UNITED STATES PATENT AND TRADEMARK OFFICE

APPLICATION NO.	FILING DATE	FIRST NAMED INVENTOR	ATTORNEY DOCKET NO.	CONFIRMATION NO.
10/019,689	01/04/2002	Gerd Eisenblatter	87307.00025	7795

Office Action Summary

DETAILED ACTION

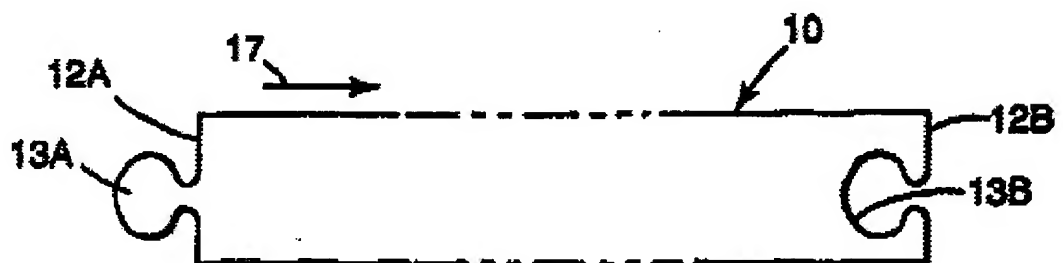
In view of specification and 112 rejections above, if the Applicant's attempt is to claim a key-hole shape as in Figs. 1 (a-c), obviousness rejection of the above claims over Muller applies as follows:

Muller discloses all the limitations of claim 1, except for disclosing a hole with a wider region on top and a narrow region on the bottom, since applicant has not disclosed that these specific shapes, e.g., key-hole, solves any stated problem or is for any particular purpose and it appears that the invention would perform equally well with hole as disclosed by Muller, it would have been an obvious matter of design to use a key-hole shape, however, It would have been obvious to one of ordinary skill in the art, at the time the invention was made, to modify the hole (18) by providing a keyhole shape for easier mating operation with the counterpiece (19).

Muller as modified above meets the limitations of claim 2.

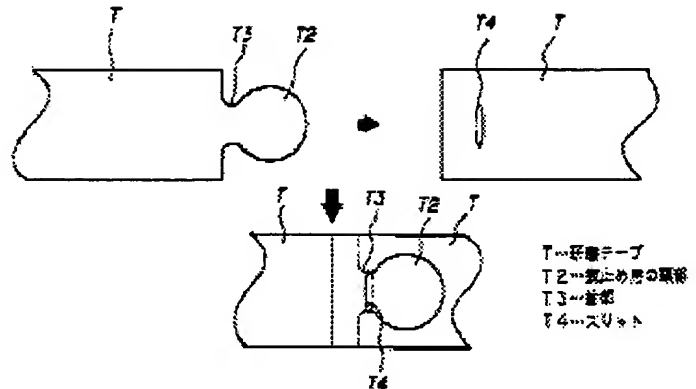
Stubbs et al. discloses all the limitations of claim 1, i.e., an interlocking abrasive belt having a keyhole shape (13B) and a counterpiece-

locking mate (13A), except for disclosing a closed end for the hole.

Takagi et al. teach an interlocking abrasive member with a recess having a closed end. It would have been obvious to one of ordinary skill in the art, at the time the invention was made, to modify the interlocking members of Stubbs et al. with a closed end as taught by Takagi et al. to strengthen the recess.

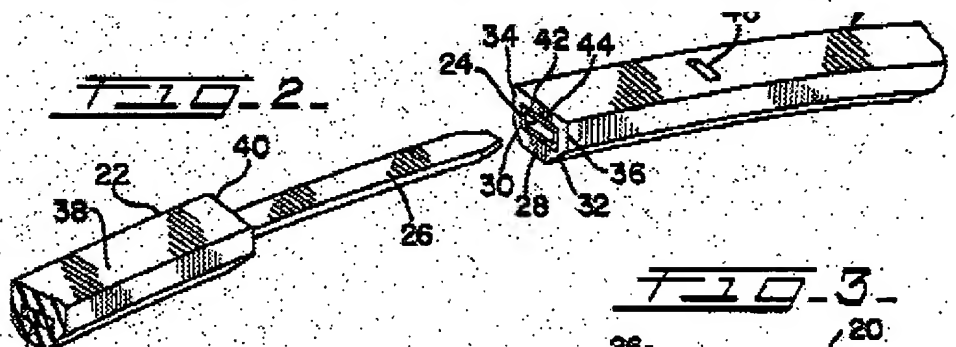
19. Claims 3-8 are rejected under 35 U.S.C. 103(a) as being unpatentable over Prior Art (Stubbs in view of Takagi) as applied to claims 1 and 2 above, and further in view of Razien, US 4,828,538.

Prior art as applied to claim 1 above meets all the limitations of the above claims except for disclosing a coated stiffened end region. Razien teaches a drive belt having interlocking members (24) (26) wherein one of the members is stiffened and coated with Teflon™. It would have been obvious to one of ordinary skill in the art, at the time the invention was made, to further modify the modified invention of the prior art with hardening coating agent as taught by Razien for durability.
